Access Compliance Report

Public Rights-of-Way

(Curb Ramps)

Intersection ID: 32144	Main Street: GREEN_CANE_DR	Cross Street: NEVERMORE_WY	Location: NE
ADA ID: 644144CD14EA	Ramp Type: BlendTrans1	Initial Pass/Fail: Fail	Overall Compliance: No
		Severity Score: 8.75

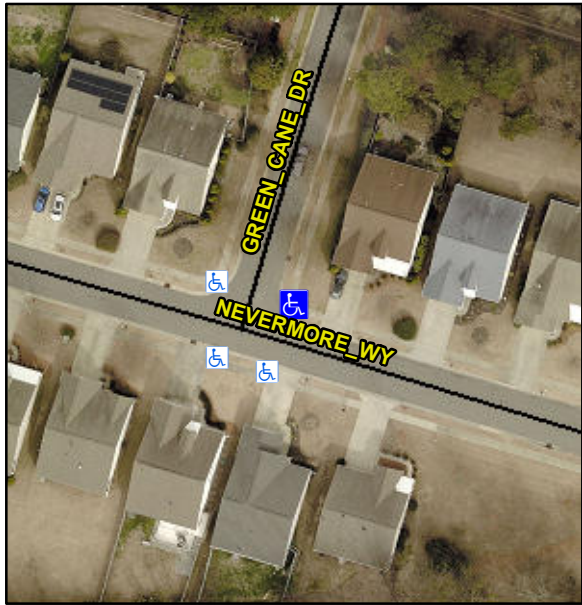
Codes/Mitigation Info/Possible Solution			Field Measurements/Component Compliance					
	Possible Solutions:		Compliance	Description	Data	Compliance	Description	Data
	Remove & Replace Curb Ramp With Two New Directional Ramps or Equivalent.		N/A	Ramp Length (in)	47.0	Yes	BlendTrans Slope (%)	4.9
			No	Ramp Width (in)	44.0	Yes	BlendTrans XSlope (%)	0.9
			N/A	Flare Type LT	N/A	N/A	Flare Type RT	N/A
			N/A	Flare Slope LT (%)	N/A	N/A	Flare Slope RT (%)	N/A
			N/A	Flare Traversable LT?	N/A	N/A	Flare Traversable RT?	N/A
			N/A	Landing Length (in)	N/A	N/A	DWS Provided?	N/A
			N/A	Landing Width (in)	N/A	N/A	DWS Contrast?	N/A
			N/A	Landing Slope (%)	N/A	N/A	DWS Length (in)	N/A
			N/A	Landing X Slope (%)	N/A	N/A	DWS Full Width?	N/A
Surveyor Notes:		N/A	N/A	Landing Curb? (Y/N)	N/A	N/A	DWS Offset (in)	N/A
PROW/ADA:		Not Found, R304.5.1	N/A	Shared Landing?	N/A			
			N/A	Gutter Ponding?	N/A	N/A	Gutter Slope (%)	N/A

N/A	Gutter Lip Ht (in)	N/A	N/A	Gutter X Slope (%)	N/A
			N/A	Painted X Walk1?	No	N/A	Painted X Walk2?	No
				X Walk 1 Direction	To W		X Walk 2 Direction	To S
				X Walk 1 Width (in)	N/A		X Walk 2 Width (in)	N/A
				X Walk 1 Slope (%)	1.9		X Walk 2 Slope (%)	2.4
				X Walk 1 X Slope (%)	0.6		X Walk 2 X Slope (%)	1.8
			N/A	Ramp inside XWalk1?	N/A	N/A	Ramp inside XWalk2?	N/A
				Road Slope (%)	0.8		Clear Space?	N/A
				Road X Slope (%)	1.7	N/A	Clear Space to XWalk (in)	N/A
			N/A	Any Obstructions?	N/A	N/A	Storm Grate/Utility Hazard?	N/A
				Obstruction Type			Storm Grate/Utility Type	
					N/A			N/A
						Yes	Surface Condition? (G/P)	Good
						No	Curb Slope (%)	9.9
Total Cost:		\$ 3200.00
